CPED STAFF REPORT

Prepared for the Heritage Preservation Commission
 HPC Agenda Item #4
 August 25, 2015
 BZH-28766

Property Location: 21 North Third Street (and 17 & 25 North Third Street)
Project Name: Lakeland Building
Prepared By: [Becca Farrar-Hughes](#), Senior City Planner, (612) 673-3594
Applicant: Roman Gadaskin
Project Contact: Karen Gjerstad
Ward: 3
Neighborhood: Downtown Minneapolis Neighborhood Association (DMNA)
Request: To renovate the existing building.
Required Applications:

Certificate of Appropriateness	To allow for the renovation of an existing building for a new mixed-use development that includes residential uses on the upper floors and a commercial use on the ground floor of the building located at 21 North Third Street, also known as the Lakeland Building. The structure is a contributing building in the Minneapolis Warehouse Historic District.
---------------------------------------	---

① THIRD STREET (NORTH) ELEVATION
 $\frac{1}{8}'' = 1' - 0''$

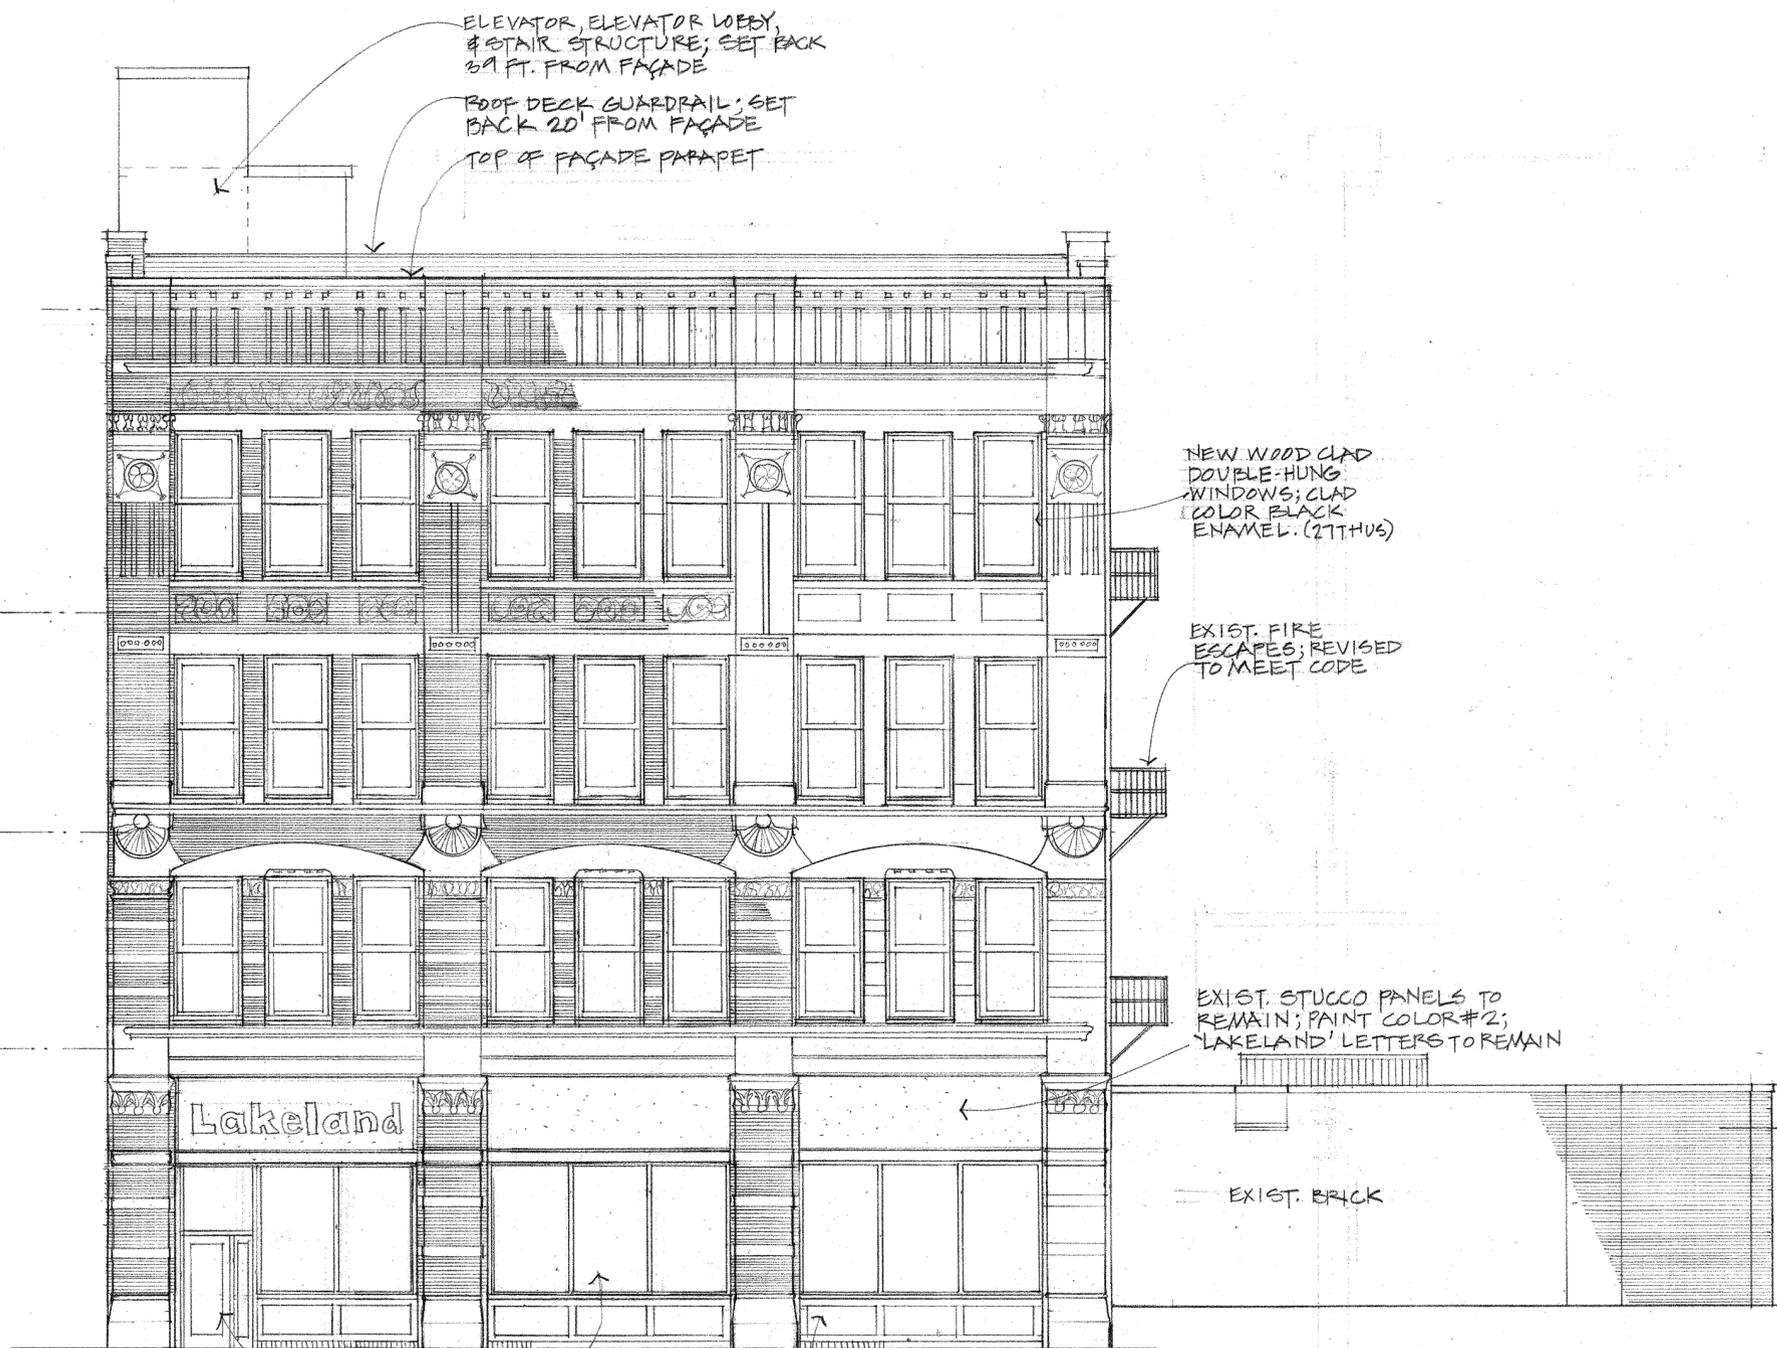
Staff comment: The applicant is proposing to remove all of the existing original double hung windows on the front façade or north elevation of the building, on floors 2-4. There are 9 windows on each floor for a total of 27 windows on the front façade. The applicant has not provided a thorough window survey but has provided a statement indicating that the windows are not in good shape. The developer met with two window restoration experts that determined most of the windows could be repaired. However, according to the developer the cost to repair the windows was unreasonable compared to installing new windows. The windows measure about 9 feet, 8 inches in height by 4 feet, 6 inches in width. As single-glazed north facing windows, the consultants felt that an additional storm/screen for both livability and heating efficiency would be necessary. The cost to building storm/screen combinations for windows of this size was estimated to be about \$2,500 to \$3,000 per window. The developer believes it is too costly to save the existing windows and is proposing a wood clad residential double hung window similar in size and profile. Staff would not support the removal of the existing windows and is instead recommending that the applicant restore the existing windows. No new window openings are proposed on the primary façade.

Staff comment: There is no photographic evidence of either the 1885 storefront or the 1919 reconstruction. On the front or north facing façade of the building, the applicant proposes to replace the non-historic glass block and brick infill that was installed in 1974 and restore the storefront. The applicant proposes a new enameled aluminum storefront with fixed windows, as well as a new door and sidelight as a replacement. The applicant proposes to retain the lower 3 feet of non-historic masonry and would clad it with fiber reinforced cementitious panels and associated trim. A horizontal member would separate the main windows from the existing upper stucco panels as this non-historic portion is proposed to be retained as well. Staff would recommend that the HPC allow the aluminum storefront but require full removal of the non-historic masonry infill that includes the base and the stucco above. Staff would recommend that the HPC require that with the full removal of the non-historic masonry infill that the approximate 3-foot base be composed of metal which is the same color or a stone base that is compatible and install transom windows as part of the storefront that are compatible with the 1919 reconstruction plans. No cementitious materials or trim shall be permitted on the building. The windows would need to be clear, insulated glazing with transom windows above compatible with the design guidelines.

6. The new storefront shall be a new enameled aluminum storefront with fixed windows, as well as a new door and sidelight as a replacement. The applicant shall fully remove all of the non-historic masonry infill. The approximate 3-foot base shall be composed of metal which is the same color or a stone base that is compatible and transom windows shall be incorporated as part of the storefront compatible with the 1919 reconstruction plans.
